LR-N07-0222

SALEM GENERATING STATION – UNIT 1 and UNIT 2
FACILITY OPERATING LICENSE NOS. DPR 70 and DPR-75
NRC DOCKET NOS. 50-272 and 50-311

**Subject: RESPONSE TO RAI #3 ON LCR S06-10 (TAC Nos. MD4843 & 4844)
STEAM GENERATOR FEEDWATER PUMP TRIP, FEEDWATER ISOLATION
VALVE RESPONSE TIME TESTING and CONTAINMENT COOLING
SYSTEM**

REQUEST FOR ADDITIONAL INFORMATION #3
REGARDING PROPOSED LICENSE AMENDMENT
STEAM GENERATOR FEEDWATER PUMP TRIP,
FEEDWATER ISOLATION VALVE CLOSURE RESPONSE TIMES,
AND CONTAINMENT FAN COIL UNIT COOLING WATER FLOW RATE
SALEM NUCLEAR GENERATING STATION, UNIT NOS. 1 AND 2
DOCKET NOS. 50-272 AND 50-311

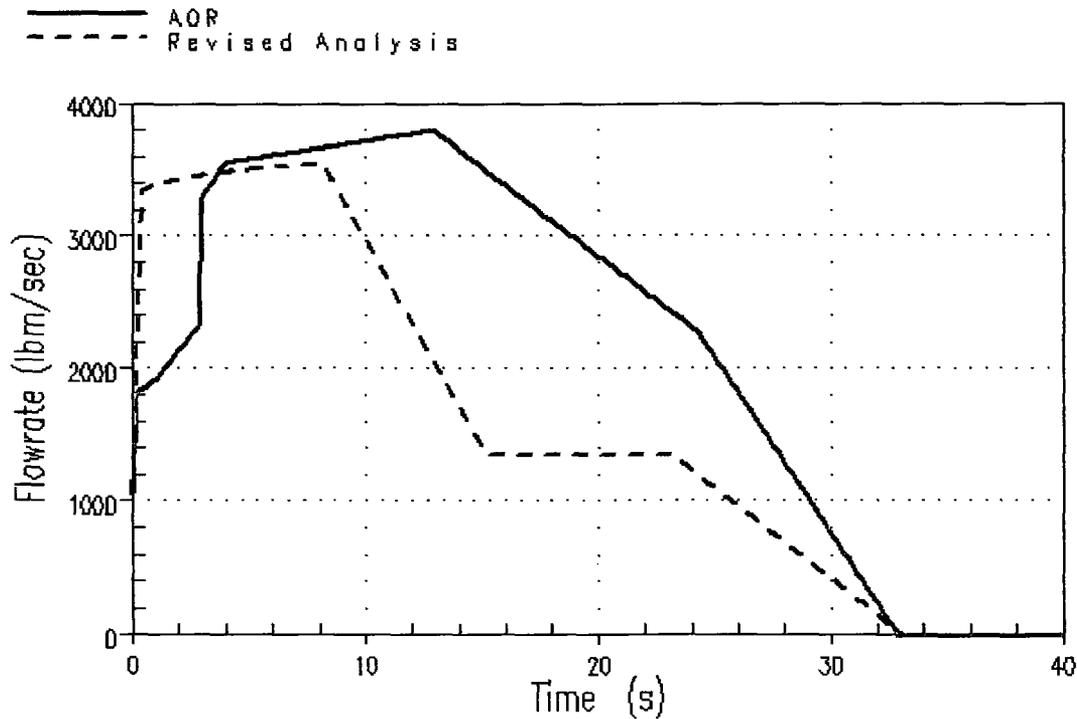
The NRC staff requests the following clarifications:

- a) How does the FW flow to the faulted SG differ between the AOR and the revised model?

RESPONSE (SCVB-1a)

The AOR does not assume full feedwater flow to the faulted SG for 32 seconds. The overly conservative assumption of the AOR was that the trip of the main feedwater (MFW) pumps was not considered. However, the AOR had complex assumptions associated with the effect of valves. It assumed 1) a ramp opening of the feedwater control valve (FCV) on the faulted loop at the beginning of the event lasting until 3 seconds after the SI setpoint is reached, 2) the sudden closure of the intact loops' FCVs at 2 seconds after the SI setpoint is reached, and 3) a decrease in the MFW flowrate due to the closure of the feedwater isolation valve (FIV) over the last 20 seconds of the 30-second stroke time of the FIV. These assumptions have been in the AOR since at least the 1993 Fuel Upgrade / Margin Recovery Project.

The MFW flow to the faulted SG in the latest Salem analysis has credited the benefit of the MFW pump trip, but is based on more conservative assumptions (i.e., more limiting for the analysis) than the AOR relative to the modeling of valve positions and their effect on the MFW flowrate. The revised analysis conservatively assumes that the FCV on the faulted loop immediately fully opens in response to the steamline break, while the FCVs on the intact loops are assumed to immediately close. The revised analysis also credits a flow reduction due to the closure of the FIV during only the last 10 seconds of the 30-second stroke time.

This discussion pertains to the SLB cases with a single failure of the FCV (failed open) on the faulted loop. It also only addresses the addition of MFW due to pumped flow; there is additional MFW added to the faulted SG due to flashing of the water in the unisolable feedline volume between the SG and the FIV, after the FIV closes. The plot below shows a comparison of the pumped MFW flowrate delivered to the faulted SG for the AOR compared to the revised analysis, using an example of a 1.4 ft² double-ended rupture SLB on Unit 2 initiated from full power.

SGFP Coastdown Assumption Sensitivity

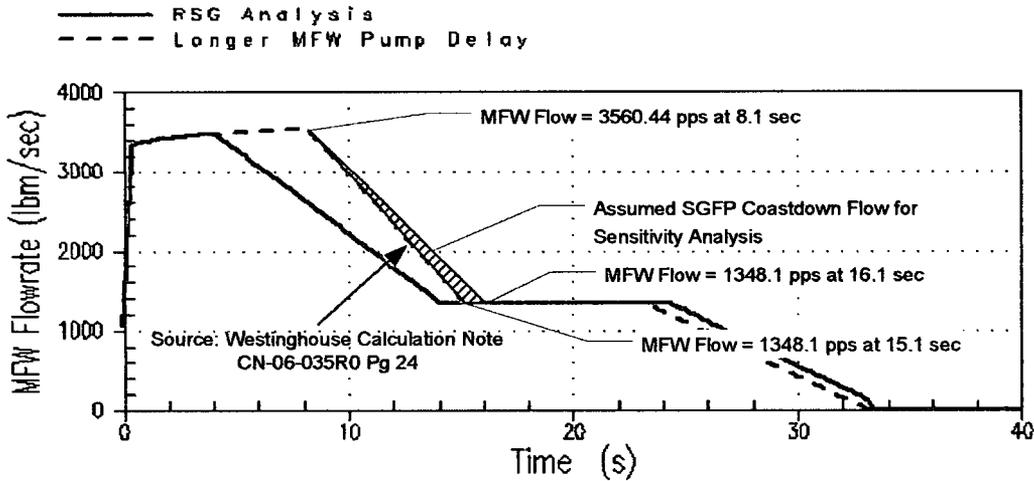
- c) What is the sensitivity of the Salem analysis if the SGFP takes longer than 7 seconds to coastdown?

RESPONSE (SCVB-2c)

The figure below is a markup of a feedwater flow plot from Westinghouse CN-CRA-06-035 which shows the sensitivity of the feedwater flow to the pump coastdown time. In the plot, the SGFP trip occurs at 8.1 seconds into the transient. The Main Feedwater (MFW) flow decreases from a peak of 3560.4 lb/sec (pps) to 1348.1 lb/sec following pump coastdown. Neglecting the change in SG pressure over the interval of the increased SGFP coastdown (15.1 to 16.1 seconds) time will have minimal impact. The integrated MFW mass will increase by approximately 1100 lbm using the integrated hatched area from the plot below. The sensitivity of the containment peak pressure to a change in integrated mass flow is approximately $1.52E-4$ psig/lbm based on an extrapolation of the CN-CRA-06-035 calculated containment peak pressures and integrated feedwater mass. The result is that the 1 second increase in the SGFP coastdown time would increase the integrated MFW mass by approximately 1100 lbm and would increase the containment peak pressure by 0.17 psig. The Unit 2 containment peak pressure for this scenario would be approximately 44.27 psig, which is less than the containment design pressure of 47.0 psig and would be acceptable.

For comparison, the limiting Unit 2 RSG case is a 1.4 ft² Double Ended Rupture (DER) at 30% Power with a containment safeguards train failure and has a peak containment pressure of 45.6 psig. The change in SGFP coastdown characteristics only affects those containment analysis transients that assume a feedwater regulating valve failure.

Therefore, an increase in the coastdown from 7 seconds to 8 seconds has a minimal impact on the integrated mass flow and containment peak pressure.
